RE – Yass Valley Wind Farm Preferred Project Report response (our ref. 4743)

ISSUES AND APPROACH OVERVIEW

1 CLARIFICATION OF ISSUES / DISCREPANCIES RAISED IN OEH SUBMISSION

TITLE
Biodiversity
High constraint areas

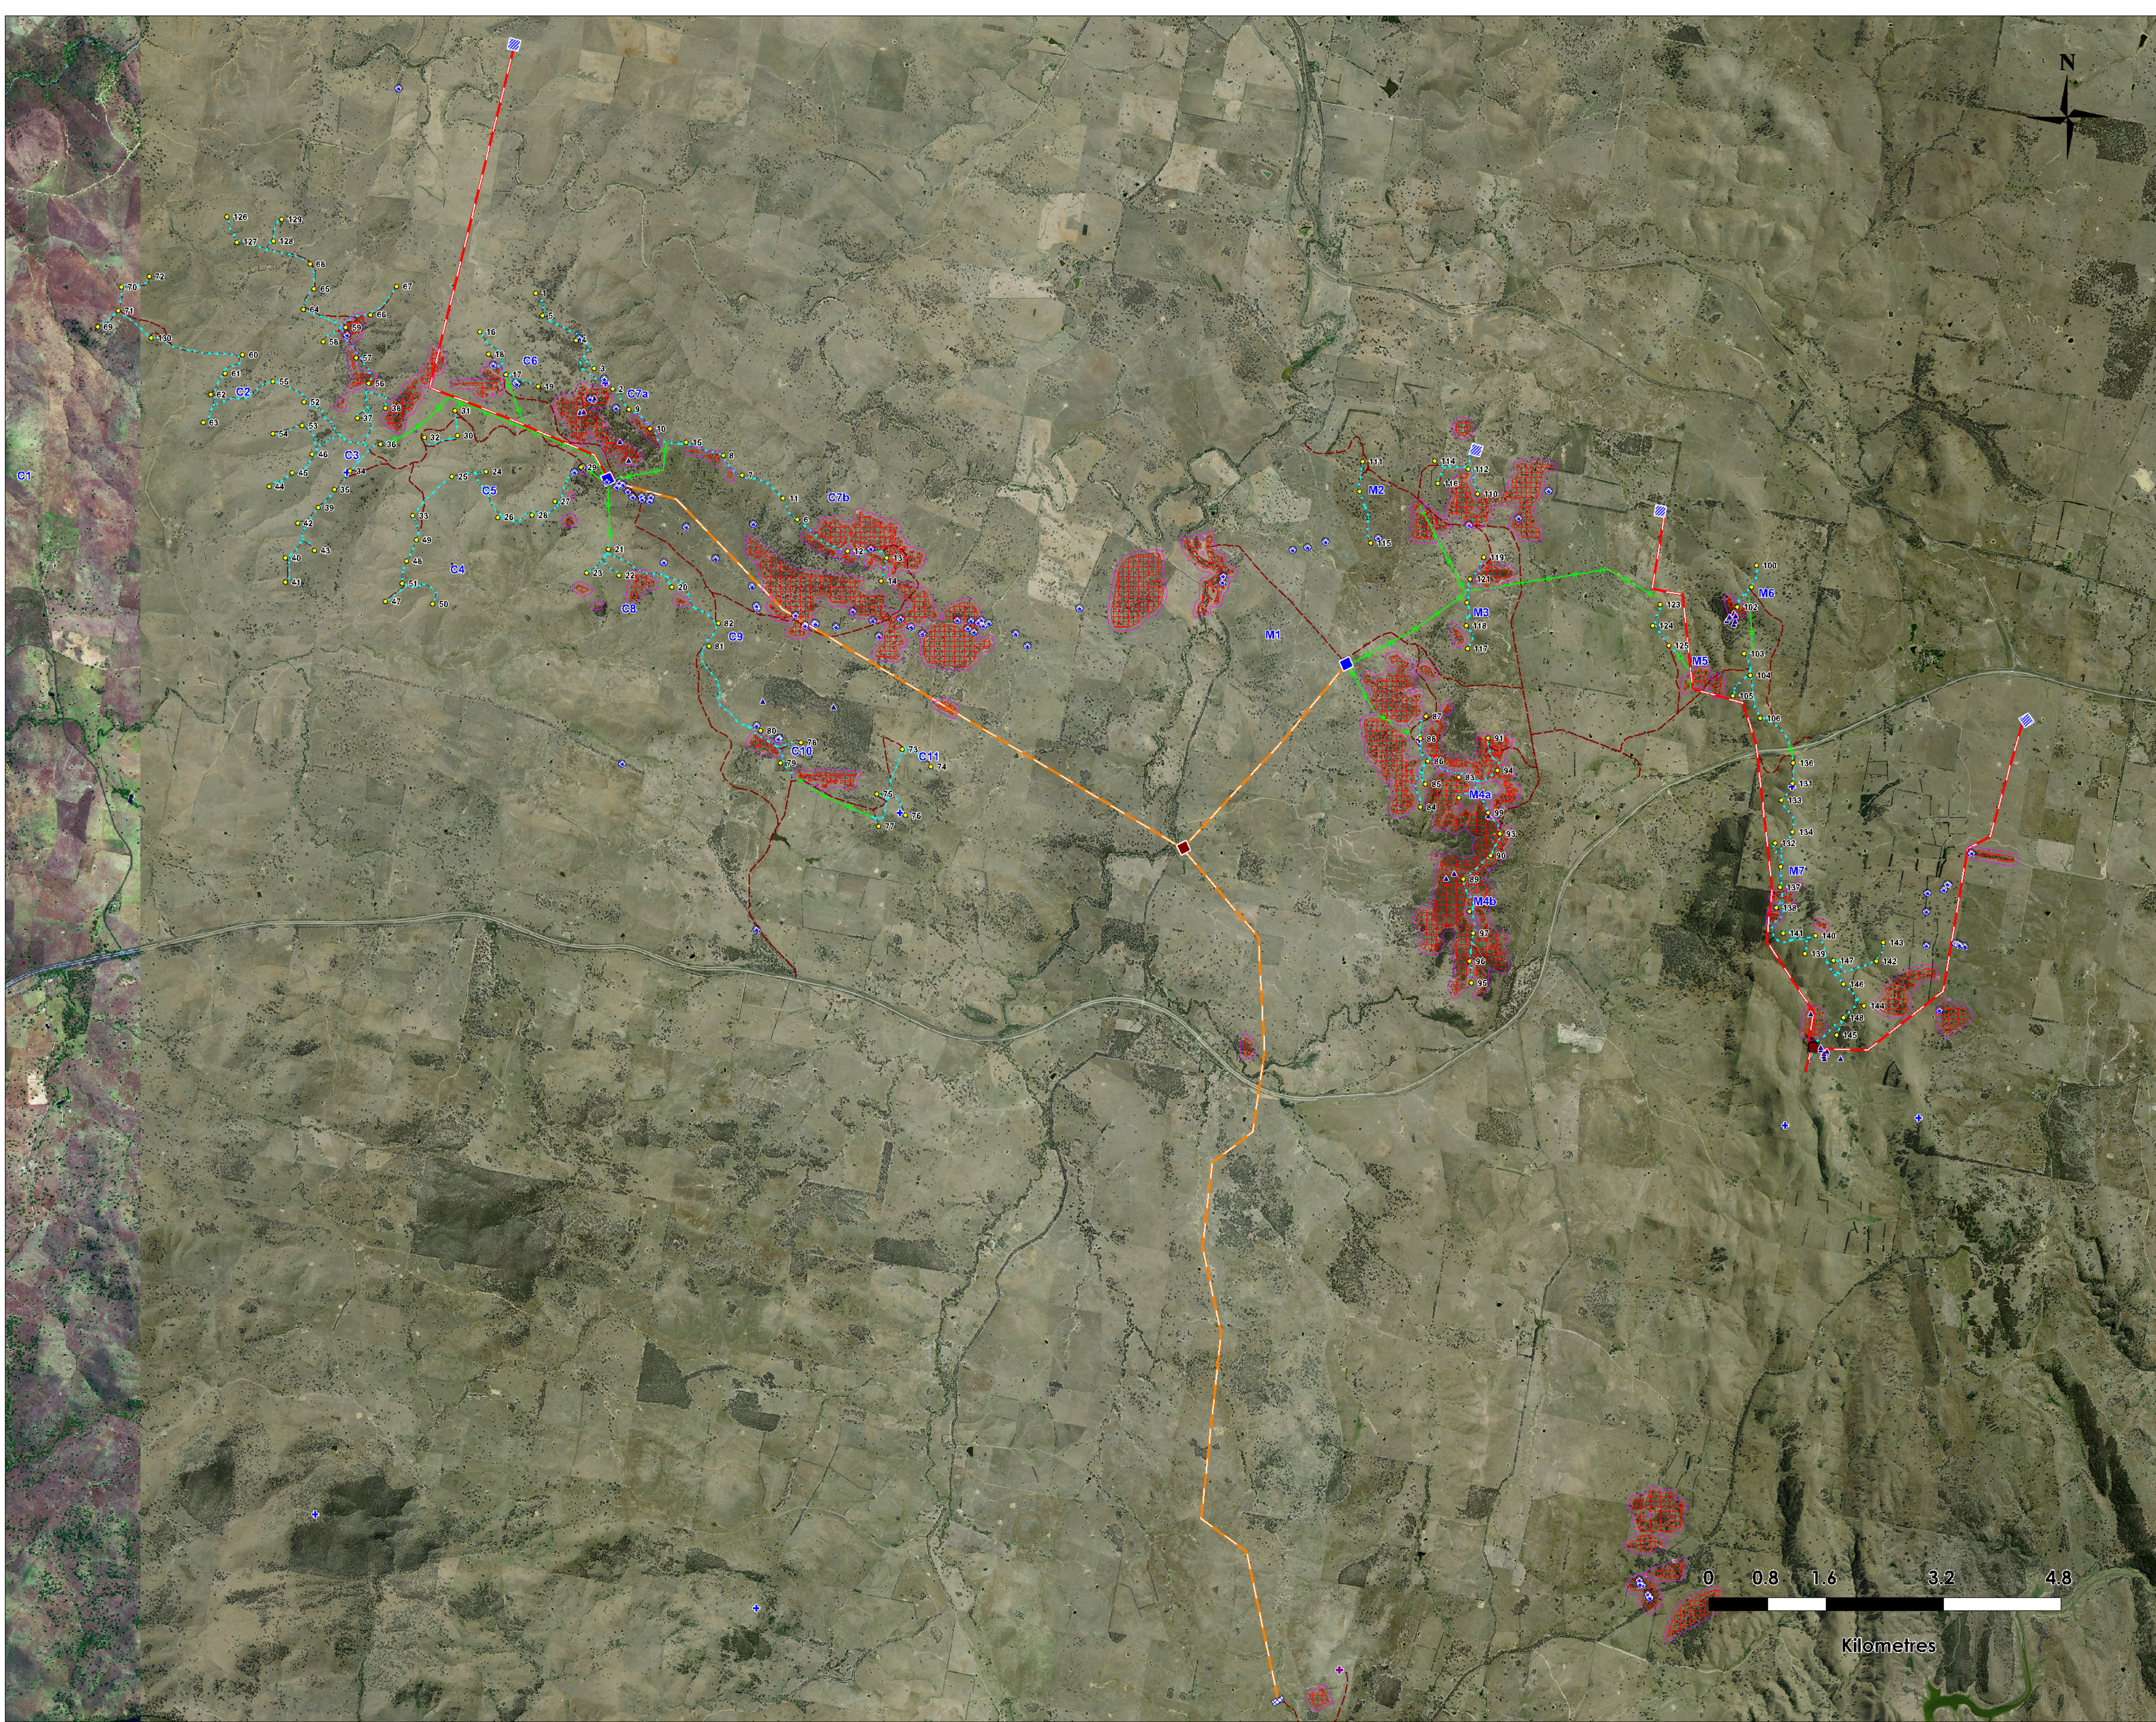
<p>OEH contend that some areas mapped as moderate constraint should be high constraint and avoided. In their letter they use 'high constraint' synonymously with 'high conservation significance'. Our classification of constraints categories is not only based on whether an area is an EEC or provides threatened species habitat, but on whether the type of impact expected could generate a significant impact to a listed entity or an impact that cannot be withstood without local population consequences. Hence we have areas of EEC in moderate to good condition that we contend the removal of would not constitute a significant impact and could be offset, albeit at a high offset ratio. The same vegetation qualities could be deemed a high constraint when near a turbine (and should be avoided) or a moderate constraint, when near a transmission line (to be minimised, managed and offset), due to the difference in impacts expected. The complexity of this has led to a misunderstanding regarding the definition of high conservation value areas.</p> <p>In discussion with Mark Henery, October 2013, we clarified the statements in OEH's submission regarding areas of high conservation significance and areas nominated</p>	Level of constraint	Colour	Description	High constraint	Red	Impacts in these areas may be significant and should be avoided. Impacts cannot be offset or may be very costly to offset. Further assessment may be required to inform impact significance.	Moderate constraint	Orange	Impacts to these areas should be minimised and/or will require specific measures to manage impacts. Residual impacts should be offset.	Low constraint	Green	No specific mitigation measures required – development most appropriate located in these areas.	<p>Pre approval</p> <p>Using the updated vegetation maps (discussed above), updated constraints mapping is proposed, in consultation with OEH. High constraint areas = avoidance, as per the existing statements of commitment. We propose to develop a high constraint shape file in consultation with OEH to ensure the approval includes avoidance in these areas. The scale would be sufficient to show any allowable tracks through high constraint areas.</p> <p>As this mapping will affect the offset requirement and potentially the final infrastructure layout, this is proposed to be done well in advance of construction, with input from OEH. The first draft is supplied with this letter, for consideration.</p> <p>The result will ensure that a final map set can accompany the BMP which marks all high constraints for avoidance, giving certainty to OEH and Epuron, regarding infrastructure placement.</p> <p>Post approval</p> <p>Moderate constraint areas will require detailed protocols, mostly centred on preclearance surveys to relocate, minimise harm and / or ensure an offsetting requirement is recorded. They would be mapped as part of the BMP but are not proposed to be mapped at this stage. They would include rocky outcropping, trees greater than 40cm dbh, Golden sun moth habitat.</p>
Level of constraint	Colour	Description												
High constraint	Red	Impacts in these areas may be significant and should be avoided. Impacts cannot be offset or may be very costly to offset. Further assessment may be required to inform impact significance.												
Moderate constraint	Orange	Impacts to these areas should be minimised and/or will require specific measures to manage impacts. Residual impacts should be offset.												
Low constraint	Green	No specific mitigation measures required – development most appropriate located in these areas.

OEH issue	Comment / clarification	Suggested timing and approach
	<p>as high constraints to be avoided. OEH do not intend to infer that all areas of EEC, regardless of condition, should be avoided. The key issue in moving forward is agreeing which areas within the site boundary constitute high constraints to be avoided. This is a judgment call that we intend to make in consultation with OEH, to deliver revised constraints mapping for the project.</p> <p>To start this process, the following areas will be mapped as high constraint (to avoid) on the advice of ngenvironmental. Epuron will finalise this mapping with input from OEH.</p> <p>High constraints from the BAs and SER are mapped. This includes:</p> <ul style="list-style-type: none"> • WF site (BAs): <ul style="list-style-type: none"> ○ EEC in ‘moderate, moderate to good and good’ condition ○ Woodland fauna and threatened fauna habitat ○ Marked hollow bearing trees (not exhaustive) • TX line (SER): <ul style="list-style-type: none"> ○ EEC in ‘moderate to good and good’ condition ○ Likely movement corridors in woodland and forest ○ Threatened species habitat <p>And additionally:</p> <ul style="list-style-type: none"> • Yass Daisy locations with 5m buffer. <p>It is noted that the impact of turbines within high constraint areas is not the same as tracks or transmission infrastructure. Some fine scale mapping has been undertaken to allow minimum width tracks in high constraint areas. In these areas, minimising impact on overstorey vegetation can be seen to have been achieved. Where transmission lines occur in high constraint areas, pole footings can be placed either side of the high constraint boundary or in a way that avoids tree clearance.</p>

Impacts to Yass Daisy at Site 35	<p>Yass Daisy were mapped as part of the Coppabella, Marilba and additional areas (SER) assessments.</p> <ol style="list-style-type: none"> 1. Coppabella - avoid clusters 6,7a, 10 = known daisy population areas 2. Marilba - avoid clusters 4, 6 and 7 = known daisy population areas 3. Additional areas (SER) – can avoid direct impacts. The search area shows the nearest records are approx. 20m from the transmission line and nearest access track. 	<p>Pre approval</p> <p>New map provided showing all locations.</p> <p>Updated constraints mapping includes all populations with a 5m buffer as high constraints to be avoided.</p>

3. High constraint High constraints from the BAs and SER are mapped. This includes:
 - WF site (BAs):
 - EEC in ‘moderate, moderate to good and good’ condition

- Woodland fauna and threatened fauna habitat
 - Marked hollow bearing trees (not exhaustive)
 - TX line (SER):
 - EEC in ‘moderate to good and good’ condition

- Likely movement corridors in woodland and forest
 - Threatened species habitat

- Yass Daisy locations with 5m buffer.

It is noted that the impact of turbines within high constraint areas is not the same as tracks or transmission infrastructure. Some fine scale mapping has been undertaken to allow minimum width tracks in high constraint areas. In these areas, minimising impact on overstorey vegetation can be seen to have been achieved. Where transmission lines occur in high constraint areas, pole footings can be placed either side of the high constraint boundary or in a way that avoids tree clearance.
4. Potential offset sites Potential offset areas include connected mature woodland, EEC and threatened species habitat.

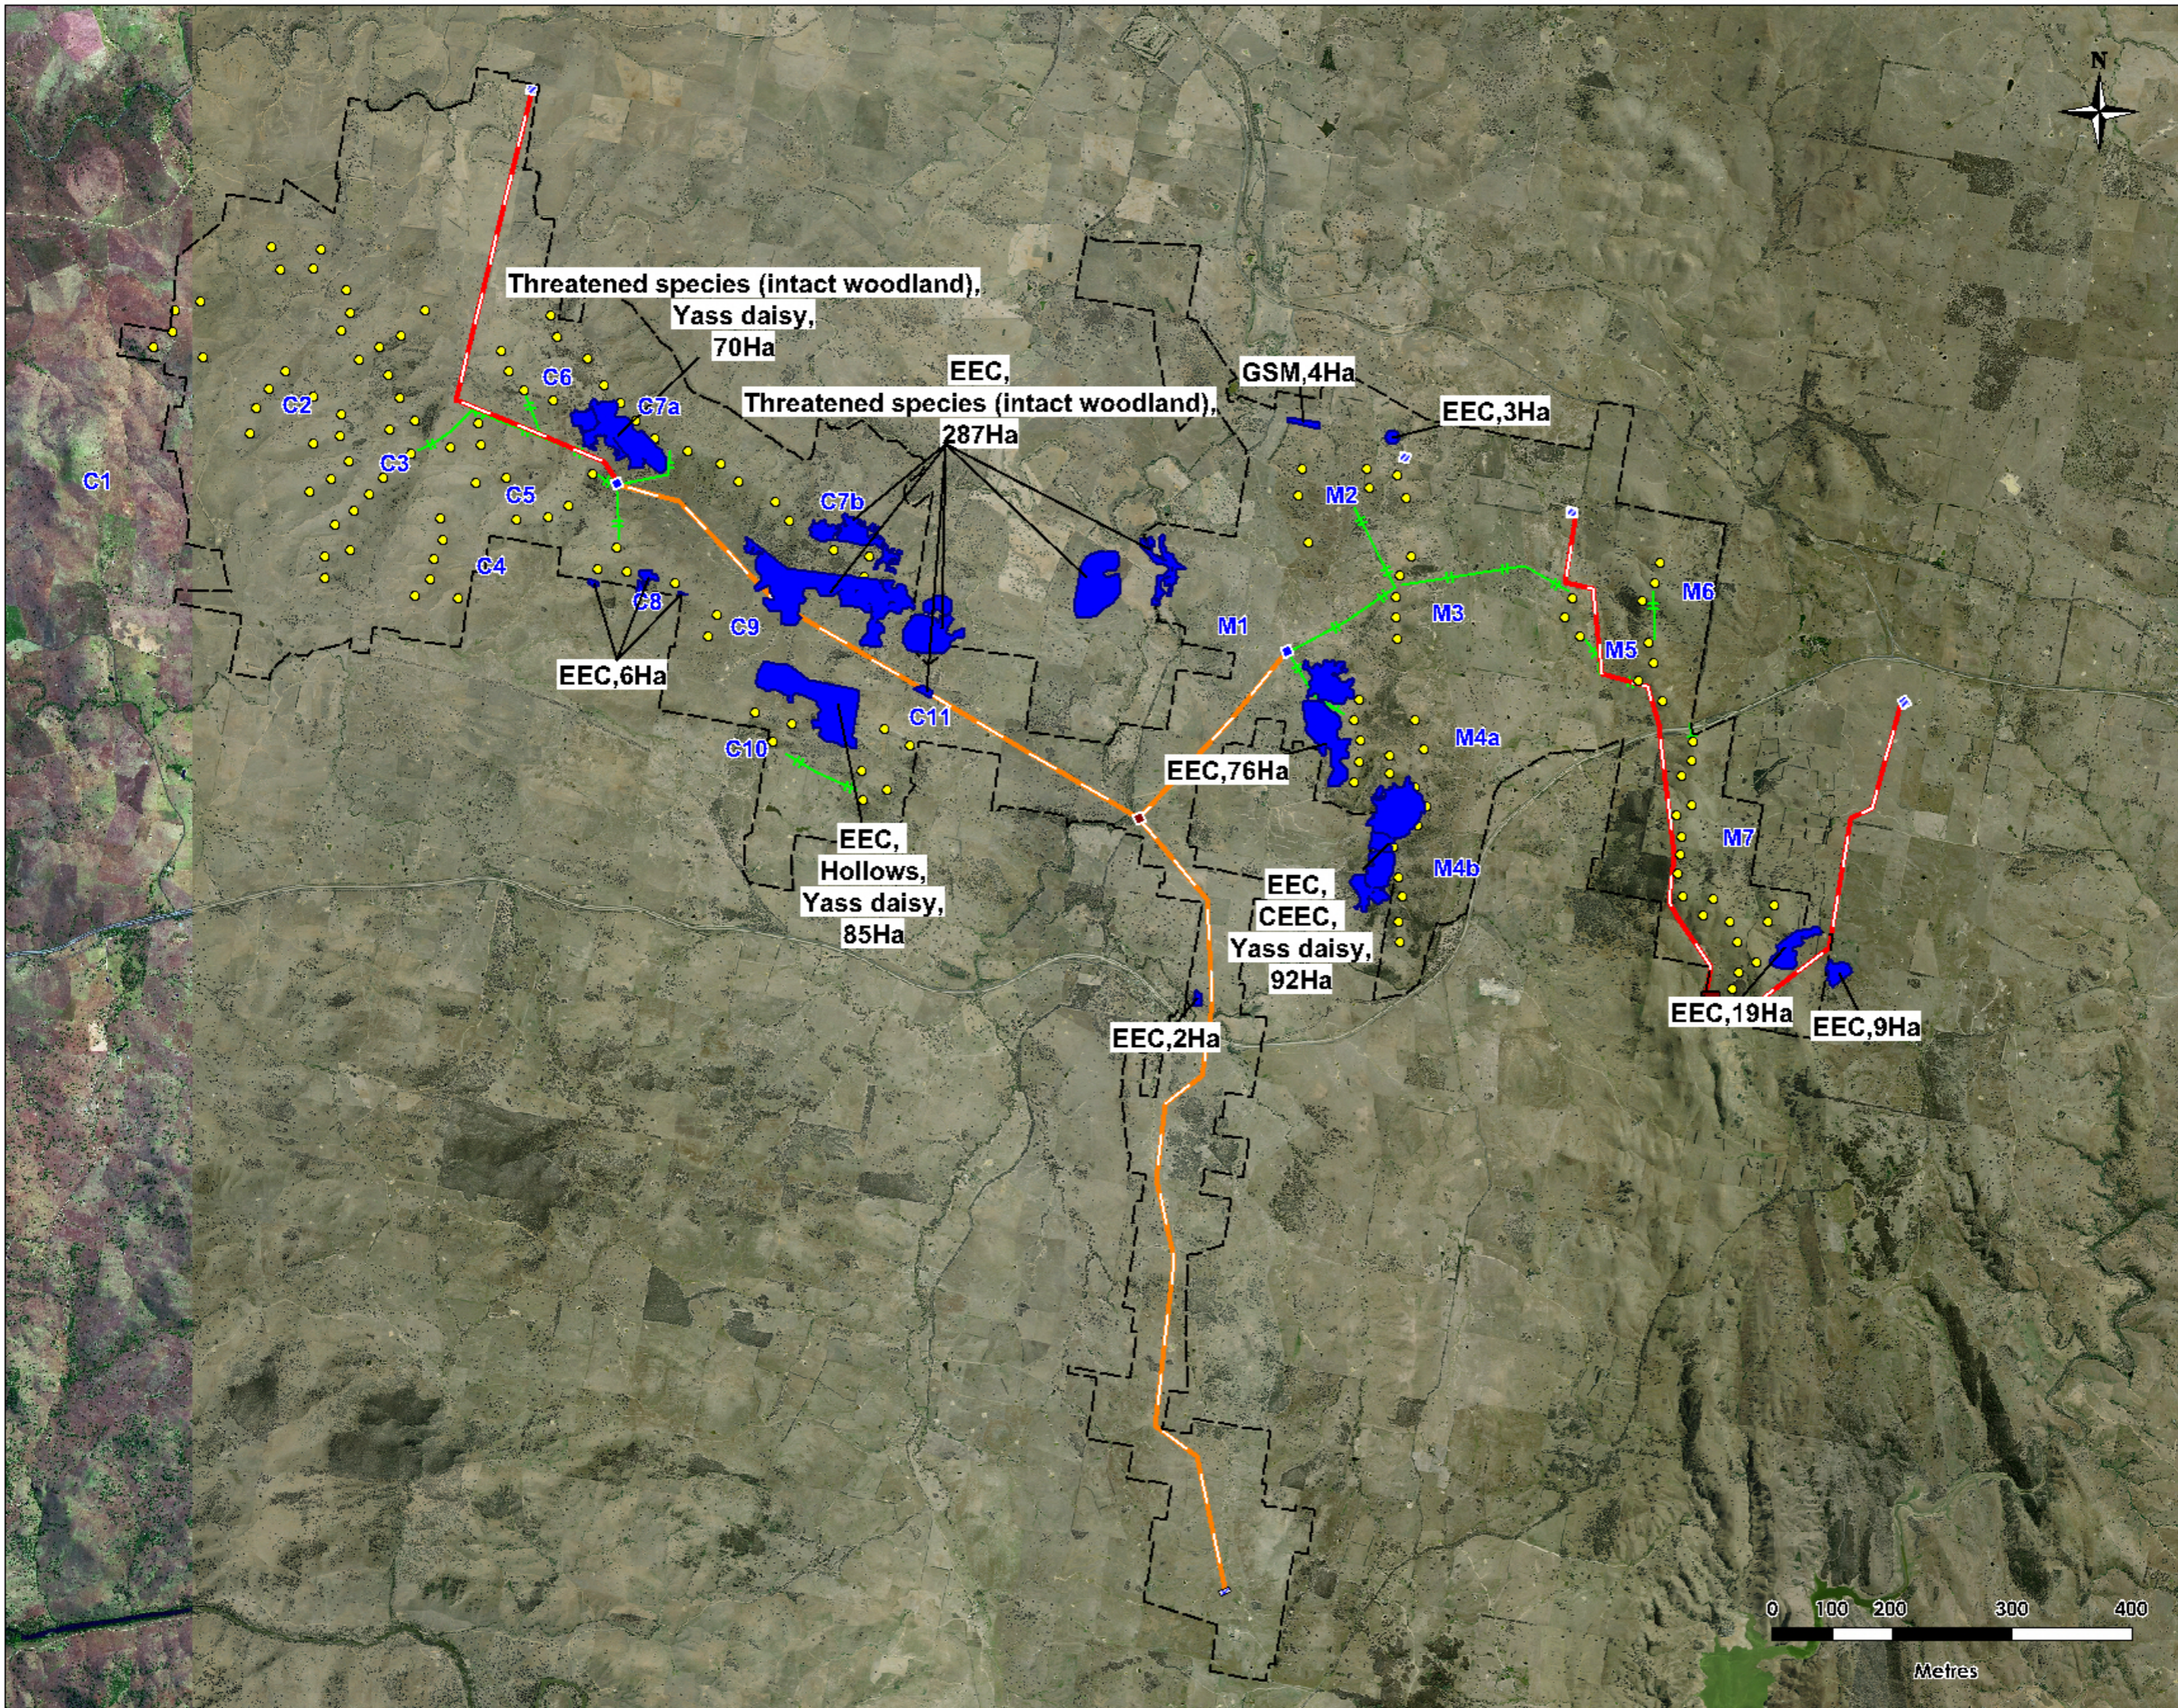
OEH issue	Comment / clarification	Suggested timing and approach
Offset proposal	<p>OEH require that the Offset Plan be developed in consultation with a number of parties and do not agree with the outline provided as Appendix F of the SER.</p> <p>A more detailed offset strategy document has been provided with this response, based on our experience securing these agreements post construction. This includes consideration of the worst case EEC impact areas and discusses potential offset sites. We believe we have demonstrated offsets within the project boundary are achievable for the project.</p> <p>We agree that the specific areas to be offset should be based on the final impact area calculations for the project and developed in consultation with the nominated parties.</p>	<p>Pre approval Strategy document provided with this response.</p> <p>Post-approval Offset plan. We suggest that OEH be the lead agency. Once a draft has been prepared, comments would be sought from the CMA and Yass Council.</p>

Some of the larger and more connected areas cited above have been mapped to indicate a potential offset package. The total area mapped totals around 650 ha. Without breaking down the specific offset requirements, this generally achieves a 1: 3 ha offset. On this basis, the security of offsets for the project is considered to be highly feasible.
